Form 3160-5
(June 2019)UNITED STATES
DEPARTMENT OF THE INTERIOR
BUREAU OF LAND MANAGEMENTFORM APPROVED
OMB No. 1004-0137
Expires: October 31, 2021**SUNDRY NOTICES AND REPORTS ON WELLS**
**Do not use this form for proposals to drill or to re-enter an
abandoned well. Use Form 3160-3 (APD) for such proposals.**5. Lease Serial No. **NMNM0438001**
6. If Indian, Allottee or Tribe Name**SUBMIT IN TRIPLICATE - Other instructions on page 2**

8. Well Name and No. **CASSIDY 18 FED COM/701H**9. API Well No. **30-015-48467**10. Field and Pool or Exploratory Area
PURPLE SAGE; WOLFCAMP (GAS)11. Country or Parish, State
EDDY/NM**12. CHECK THE APPROPRIATE BOX(ES) TO INDICATE NATURE OF NOTICE, REPORT OR OTHER DATA**

EOG respectfully requests an amendment to our approved APD for this well to reflect the following changes:

Cassidy 18 Fed Com 721H (FKA 701H) API #: 30-015-48467

Revised Wellbore

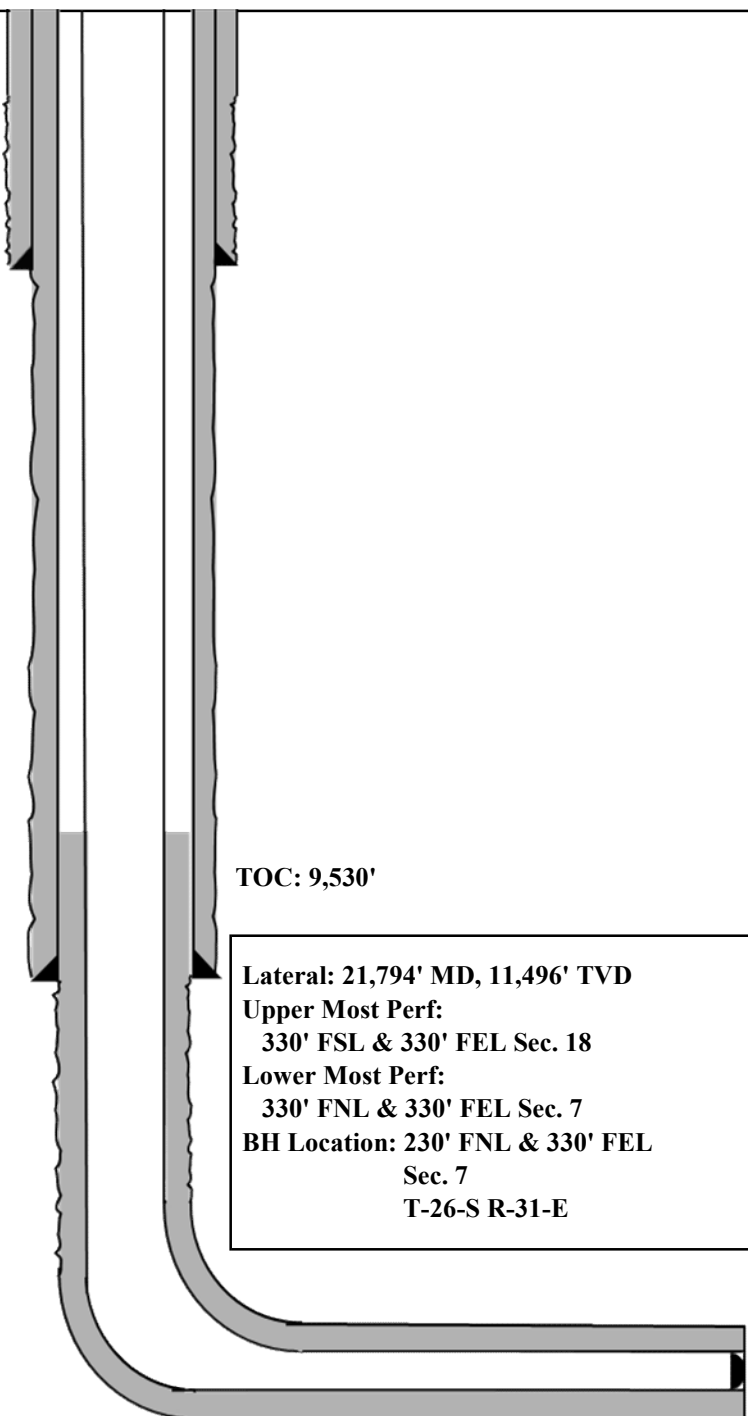
Update casing and cement program to current design.

Bit Size: 8-3/4"
7-5/8", 29.7#, HCP-110, FXL,
@ 0' - 10,030'

Bit Size: 6-3/4"
5-1/2", 20#, P110-EC, DWC/C IS MS,
@ 0' - 9,530'

5-1/2", 20#, P110-EC, Vam Sprint SF,
@ 9,530' - 10,030'

5-1/2", 20#, P110-EC, DWC/C IS MS,
@ 10,030' - 21,794'
